ADDENDUM NO. 2

Bid No.: 2526-05

Project: Roofing at Various Sites

Owner: Los Alamitos Unified School District

HOPKINSON
ES - SCOPE
CLARIFICATION

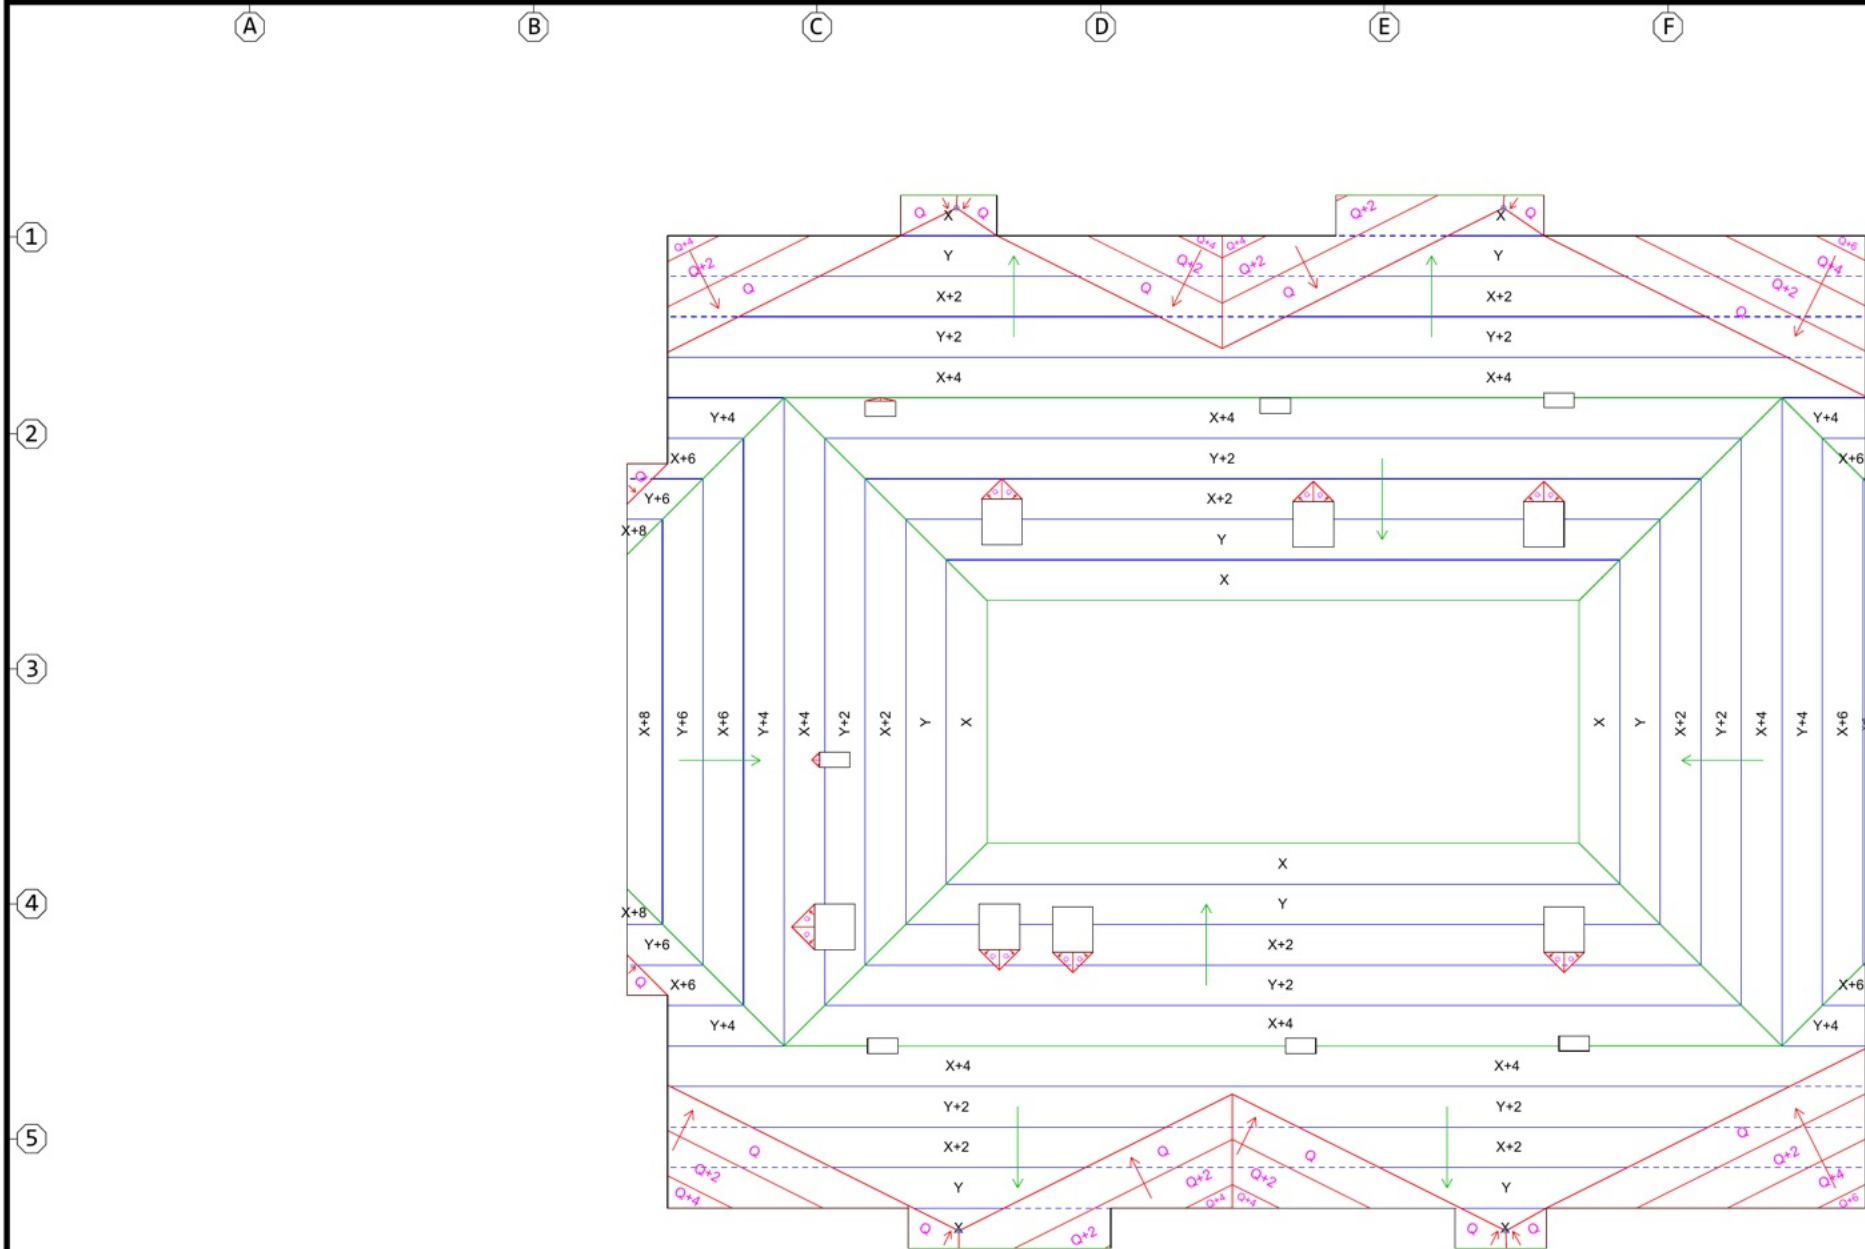
b. Roof Edge / Drip Edge Clarification

Provide new roof-edge drip edge metal at Building E to match the existing profile, configuration, and relationship to adjacent architectural metal. The new drip edge shall be installed in the same plane and termination location as the existing condition and integrated with the new roofing membrane per manufacturer-supplied details. The existing outer architectural metal fascia/perimeter beam located beyond the roof-edge drip line shall remain in place and shall not be removed, modified, encapsulated, or wrapped by the new roofing or edge-metal system.

a. Surface-Mounted Counterflashing

At the lower canopy walls indicated on the drawing set, contractor shall install approximately 100 linear feet of surface-mounted counterflashing fabricated from 22-gauge galvanized steel and installed per manufacturer-supplied details.

b. Duct Support Sleeper Pans

Contractor shall remove existing duct support sleeper pans as required to allow the new roofing membrane to be installed roof-up and over the sleepers. Roofing membrane plies shall be installed continuously beneath the sleeper pan locations to maintain a watertight assembly. Upon completion of the roofing membrane installation, contractor shall reinstall the sleeper pans. Any fasteners penetrating the top surface of the sleeper pans shall be properly sealed in accordance with manufacturer requirements to ensure a watertight condition.

- SHEET NOTES:**
1. CONTRACTOR SHALL INSTALL TAPERED POLYISO INSULATION IN ACCORDANCE WITH THE SUPPLIED TAPER PLAN ON BUILDING E.
 2. CONTRACTOR SHALL REMOVE AND REPLACE THE EXISTING ROOF-EDGE DRIP EDGE METAL WITH NEW DRIP EDGE METAL TO MATCH THE EXISTING PROFILE, CONFIGURATION, AND RELATIONSHIP TO THE ADJACENT ARCHITECTURAL METAL. NEW DRIP EDGE SHALL BE INSTALLED IN THE SAME PLANE AND TERMINATION LOCATION AS THE EXISTING CONDITION AND INTEGRATED WITH THE NEW ROOFING MEMBRANE PER MANUFACTURER'S STANDARD DETAILS. THE EXISTING OUTER ARCHITECTURAL METAL FASCIA/PERIMETER BEAM LOCATED BEYOND THE ROOF-EDGE DRIP LINE SHALL REMAIN IN PLACE AND SHALL NOT BE REMOVED, MODIFIED, ENCAPSULATED, OR WRAPPED BY THE NEW ROOFING OR EDGE METAL SYSTEM, AND THE NEW DRIP EDGE SHALL TERMINATE AT THE SAME POINT AS THE EXISTING CONDITION WITHOUT EXTENDING OVER OR CONCEALING THE OUTER METAL FASCIA/PERIMETER BEAM.

3. ON LOWER CANOPY WALLS INDICATED IN RED, CONTRACTOR SHALL INSTALL APPROXIMATELY 100 LINEAR FEET OF SURFACE-MOUNTED COUNTERFLASHINGS PER MANUFACTURER-SUPPLIED DETAILS. NEW COUNTERFLASHINGS SHALL BE FABRICATED FROM 22 GA GALVANIZED STEEL.

4. CONTRACTOR SHALL REMOVE ALL EXISTING DUCT SUPPORT SLEEPER PANS AS REQUIRED TO ALLOW THE NEW ROOFING MEMBRANE TO BE INSTALLED ROOF UP AND OVER THE SLEEPERS. ROOFING MEMBRANE PLIES SHALL BE INSTALLED CONTINUOUSLY BENEATH THE SLEEPER PAN LOCATIONS TO MAINTAIN A WATERTIGHT ASSEMBLY. UPON COMPLETION OF THE ROOFING MEMBRANE INSTALLATION, CONTRACTOR SHALL REINSTALL THE SLEEPER PANS. ANY FASTENERS PENETRATING THE TOP SURFACE OF THE SLEEPER PANS SHALL BE PROPERLY SEALED IN ACCORDANCE WITH MANUFACTURER REQUIREMENTS TO ENSURE A WATERTIGHT CONDITION.

HOPKINSON
ES - BLDG E
TAPER PLAN

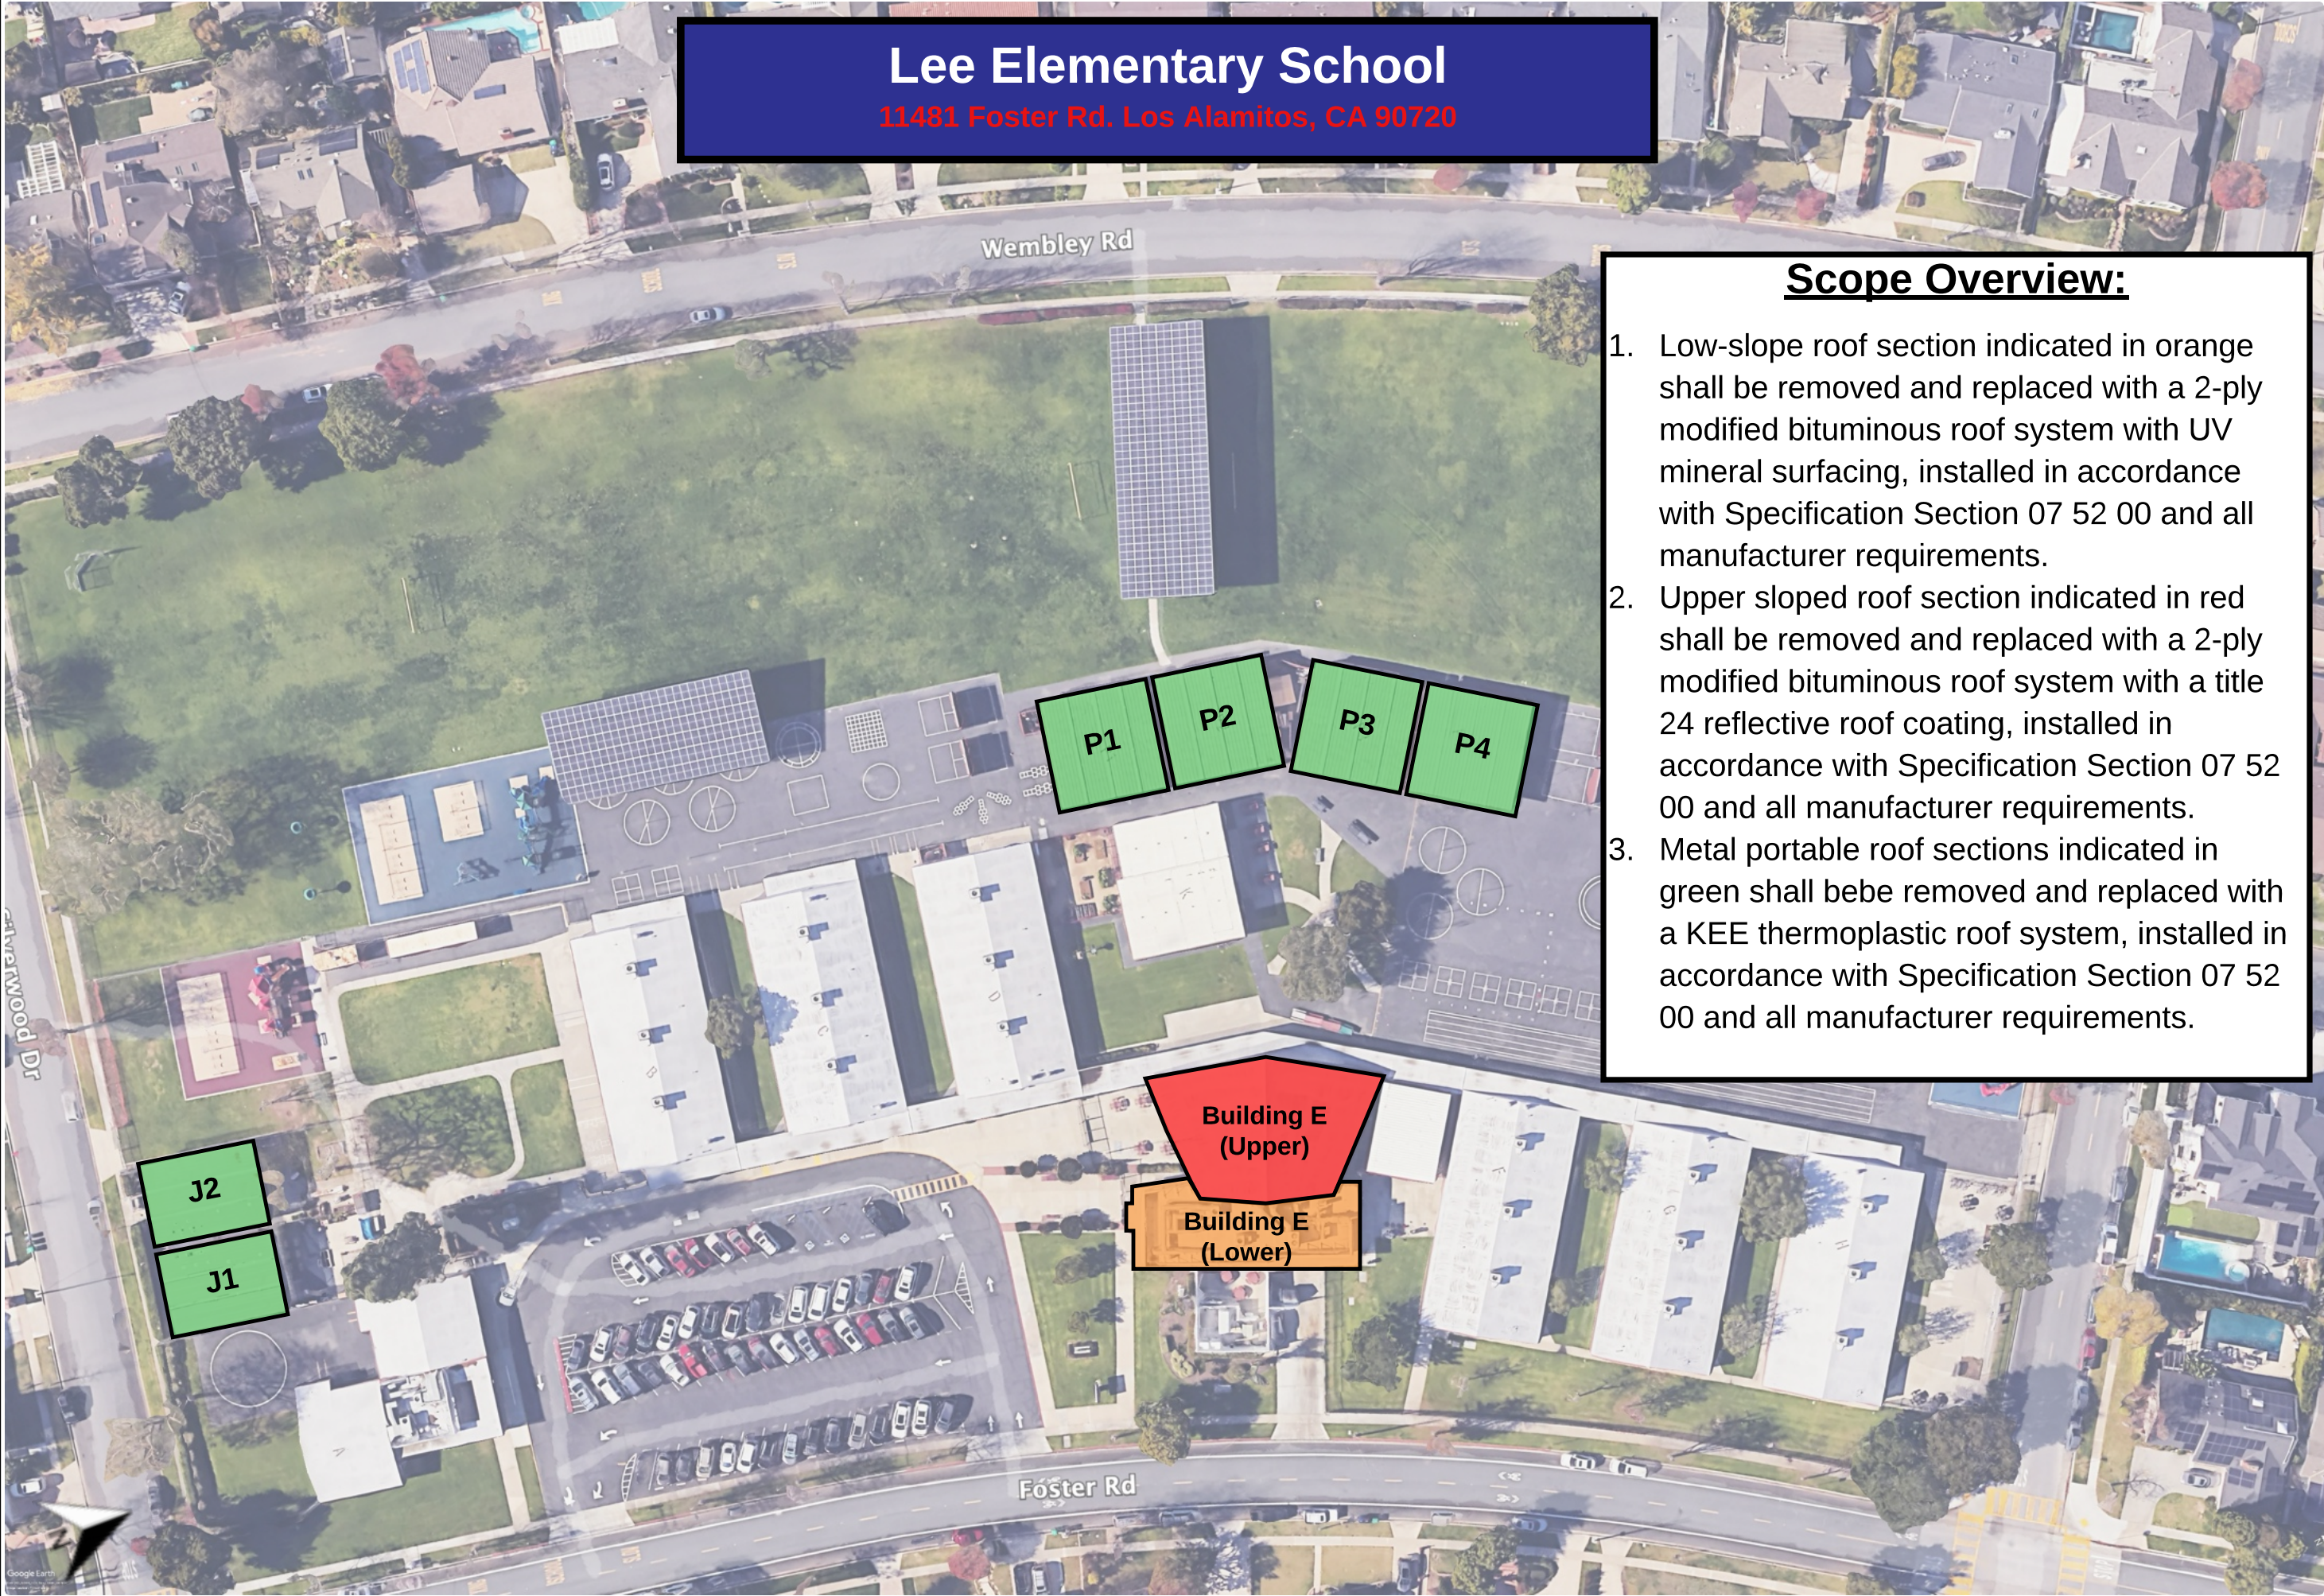
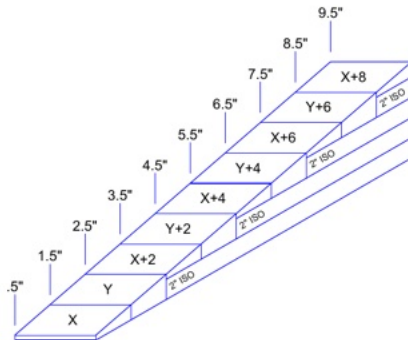
a. Tapered Insulation Design

The tapered insulation design for Hopkinson Elementary School, Building E, is provided in the Addendum No. 1 drawing set. Contractor shall prepare submittals and perform work in accordance with the Addendum No. 1 tapered insulation drawings.

LEE ES - SCOPE
CLARIFICATION

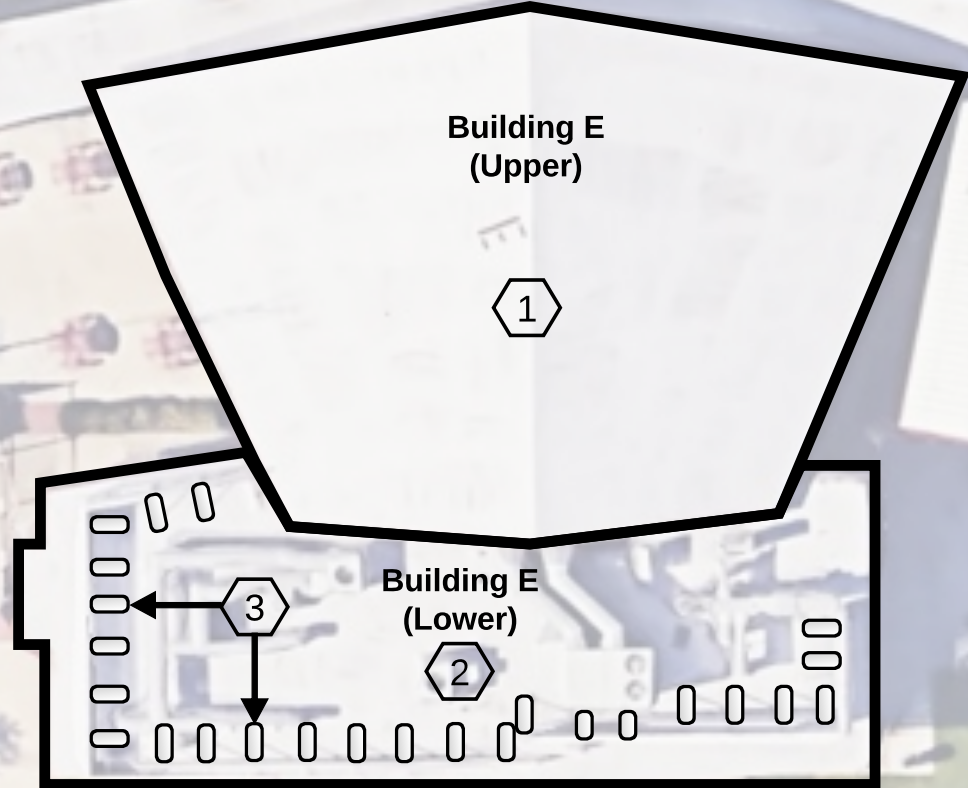
a. Upper Sloped Roof Section – Scope Revision

The upper sloped roof section of Building E shall be replaced with a 2-ply modified bituminous roof system consisting of 2 inches of polyisocyanurate insulation, 1/2-inch DensDeck Prime, and a cold-applied 2-ply modified bituminous membrane system with a Title 24–compliant reflective roof coating, as specified in Section 07 52 00.

b. Lower Low-Slope Roof Section – Scope Clarification

The lower low-slope roof section of Building E shall be replaced with a 2-ply modified bituminous roof system consisting of a mechanically attached (nailed) base sheet and a cold-applied 2-ply modified bituminous membrane system, as specified in Section 07 52 00.

c. Exposed Soffit Conditions

Where exposed soffits exist beneath the roof deck, insulation plies shall be installed using manufacturer-approved low-VOC adhesive to prevent fastener penetration through finished soffit surfaces.

d. Site Screen and Duct Support Sleeper Flashing

Contractor shall flash existing roof sleepers consisting of membrane-encapsulated curbs with metal pans and steel angle supports. Existing metal pans shall remain in place and shall be fully wrapped with a base sheet extended a minimum of 6 inches onto the field of the roof and fully adhered. The mineral-surfaced cap sheet shall then be installed over the base sheet and extended onto the field of the roof per manufacturer requirements. Steel angle supports penetrating the metal pans shall be flashed as individual penetrations using manufacturer-approved, polyester-reinforced liquid flashing installed in strict accordance with manufacturer-supplied details.

- SHEET NOTES:**
1. BUILDING E UPPER SLOPED ROOF SECTION SHALL BE REPLACED WITH A 2-PLY MODIFIED BITUMINOUS ROOF SYSTEM CONSISTING OF 2" OF POLYISO INSULATION, 1/2" DENSDECK PRIME, AND A COLD-APPLIED 2-PLY MODIFIED BITUMINOUS MEMBRANE SYSTEM WITH A TITLE 24-COMPLIANT REFLECTIVE ROOF COATING, AS SPECIFIED IN SECTION 07 52 00. WHERE EXPOSED SOFFIT CONDITIONS EXIST BENEATH THE ROOF DECK, INSULATION AND COVERBOARD SHALL BE INSTALLED IN A FULLY ADHERED APPLICATION USING MANUFACTURER-APPROVED LOW-VOC ADHESIVE.

2. BUILDING E LOWER LOW-SLOPE ROOF SECTION SHALL BE REPLACED WITH A 2-PLY MODIFIED BITUMINOUS ROOF SYSTEM CONSISTING OF A MECHANICALLY ATTACHED (NAILED) BASE SHEET AND A COLD-APPLIED 2-PLY MODIFIED BITUMINOUS MEMBRANE SYSTEM, AS SPECIFIED IN SECTION 07 52 00.

3. CONTRACTOR SHALL FLASH EXISTING ROOF SLEEPERS CONSISTING OF MEMBRANE-ENCAPSULATED CURBS WITH METAL PANS AND STEEL ANGLE SUPPORTS. EXISTING METAL PANS SHALL REMAIN IN PLACE AND BE FULLY WRAPPED WITH A BASE SHEET EXTENDED A MINIMUM OF 6 INCHES ONTO THE FIELD OF THE ROOF AND FULLY ADHERED. THE MINERAL-SURFACED CAP SHEET SHALL THEN BE INSTALLED OVER THE BASE SHEET AND EXTENDED ONTO THE FIELD OF THE ROOF PER MANUFACTURER REQUIREMENTS. STEEL ANGLE SUPPORTS PENETRATING THE METAL PANS SHALL BE FLASHED AS INDIVIDUAL PENETRATIONS USING MANUFACTURER-APPROVED, POLYESTER-REINFORCED LIQUID FLASHING, INSTALLED IN STRICT ACCORDANCE WITH MANUFACTURER-SUPPLIED DETAILS.

LAHS
500/KIT
TAPER PLAN

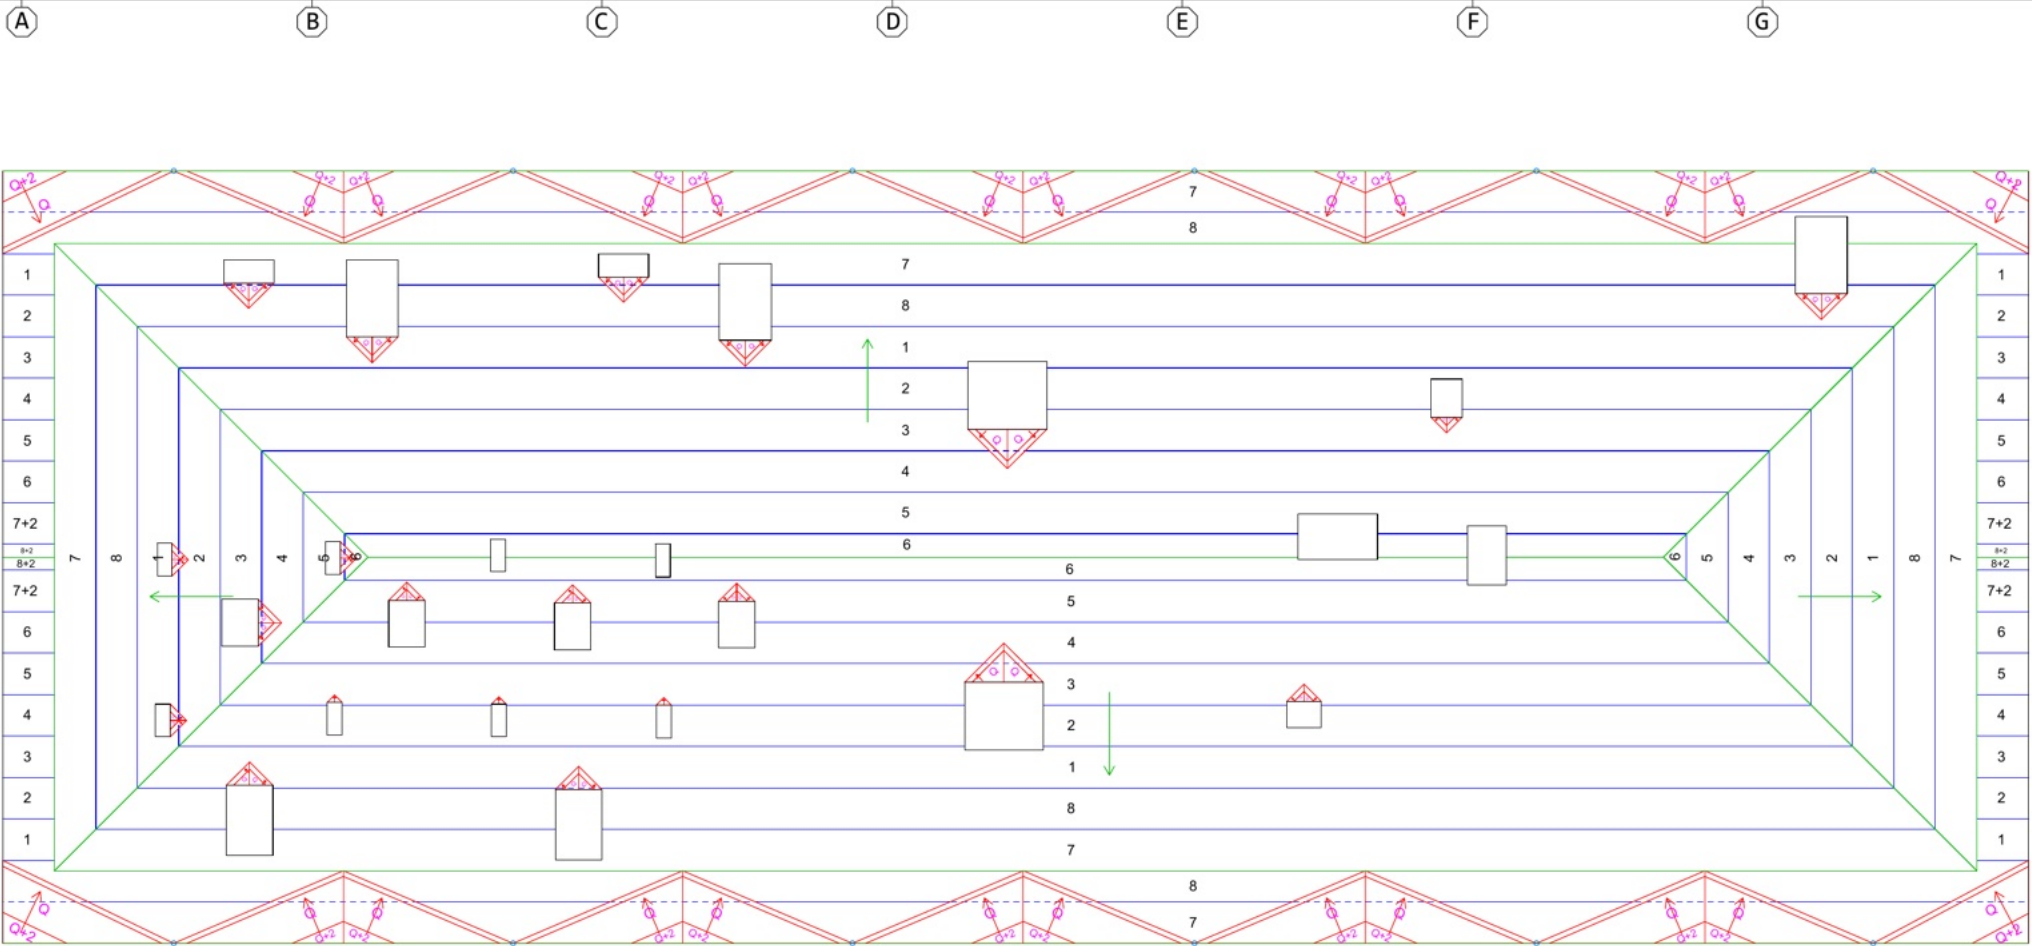
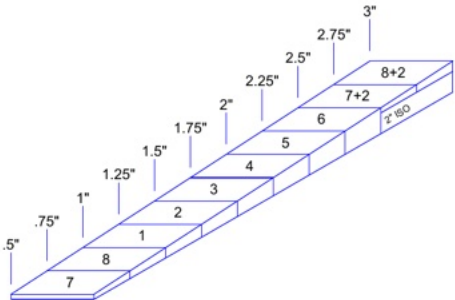
a. Tapered Insulation Design

The tapered insulation design for the 500/KIT Building is provided in the Addendum No. 1 drawing set. Contractor shall prepare submittals and perform work in accordance with the Addendum No. 1 tapered insulation drawings.
